# PERMIT CHANGE TRACKING FORM

<b>DATE RECEIVED</b>	<i>3/9/94</i>	<b>PERMIT NUMBER</b>	<i>ACT/007/007</i>
<b>Title of Proposal:</b>	<i>Dewatering Borehole</i>	<b>PERMIT CHANGE #</b>	<i>94c</i>
<b>Description:</b>		<b>PERMITTEE</b>	<i>SLC</i>
		<b>MINE NAME</b>	<i>Sunnyside Mine</i>

Re: Application for Permit Change Adding A De-Watering Borehole

Mine De-Watering Borehole

PLATE III-IDJ.

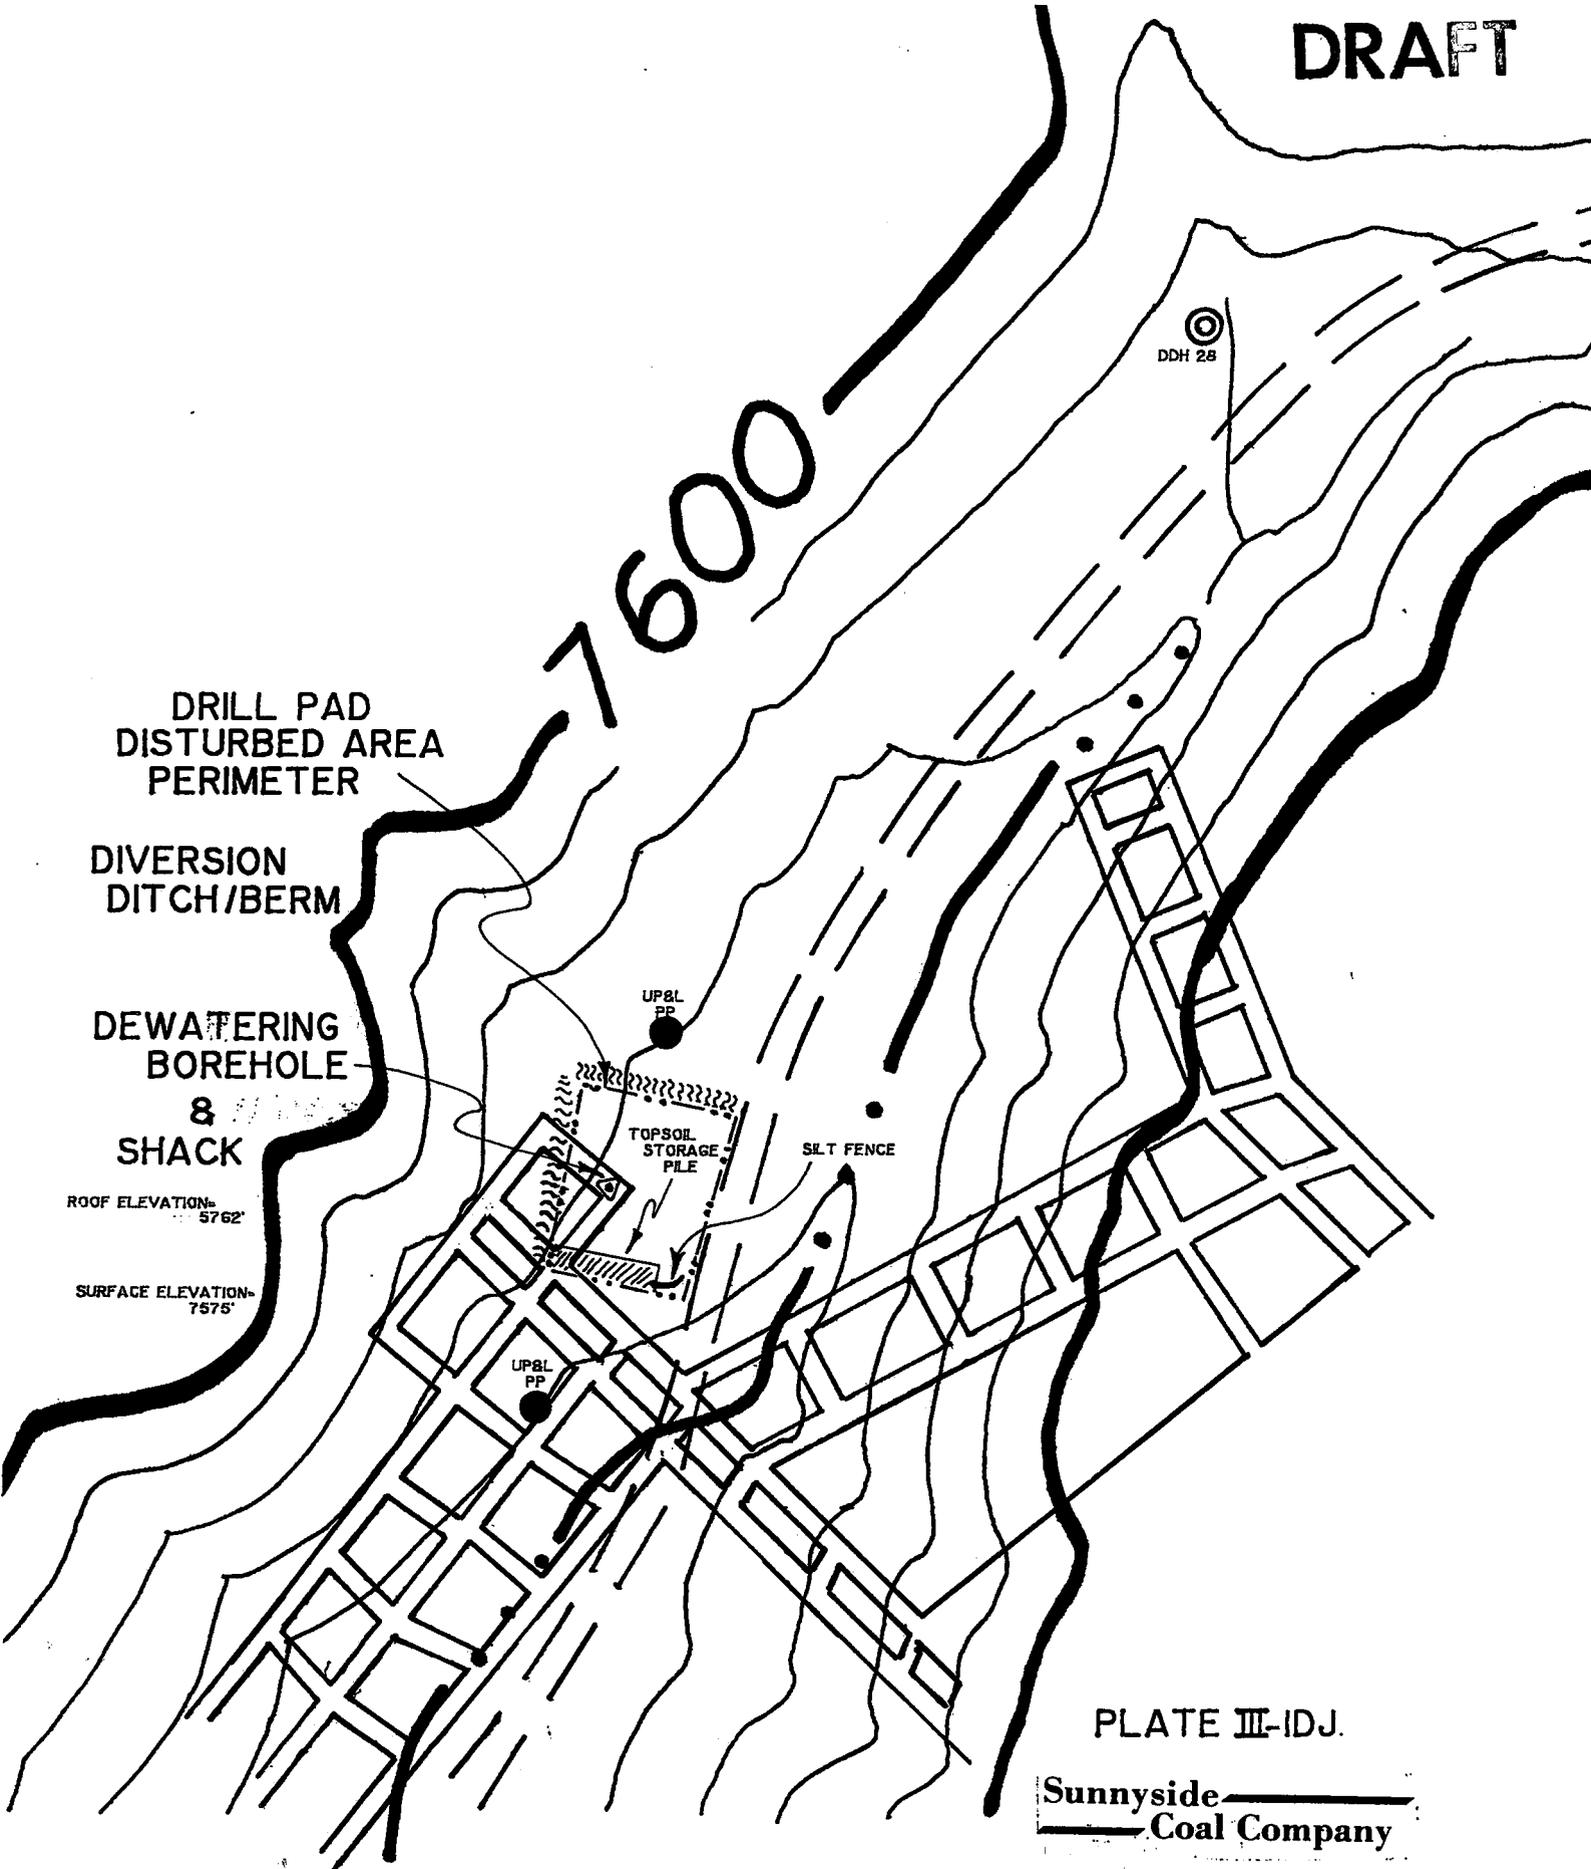
A Dewatering Borehole is scheduled for construction during 1994. The location of the borehole, temporary drilling pad, pipeline and topsoil storage pile is shown on Plates III-1Dj and k.

The borehole will be located on the surface in an area that is undisturbed (See Plate III-20). Sediment control for the drill pad area (approximately 0.7 acres) will use alternative, BTCA primary sediment control practices. These consist of undisturbed diversion ditches/berms and a silt fence and are shown on Plate III-1Dk. The temporary drill pad area will be covered with rock during use. After the borehole is drilled and the pumps installed the area will be reclaimed and revegetated so that the area will also use a vegetative cover to control sediment.

In preparation for the construction of the temporary pad, 6" of topsoil will be removed and a topsoil storage pile will be established as shown on Plate III-1Dk and Figure III-17. The capacity of the topsoil storage area is 521 cu. yds. Removal of 6" of topsoil will result in storage of 458 cu. yds. Most of the topsoil will be stored for no more than 6 months, after which time it will be redistributed in conjunction with the reclamation of the drill pad. The remaining portion will be used when the wellhead is reclaimed. The topsoil pile will be established and maintained in accordance with established Division guidelines, and as outlined in section 3.5.1.2. As an additional soil protection and sediment control measure, a berm which will be capable of containing runoff from a 100 yr. 6 hr. event will be established around the topsoil pile.
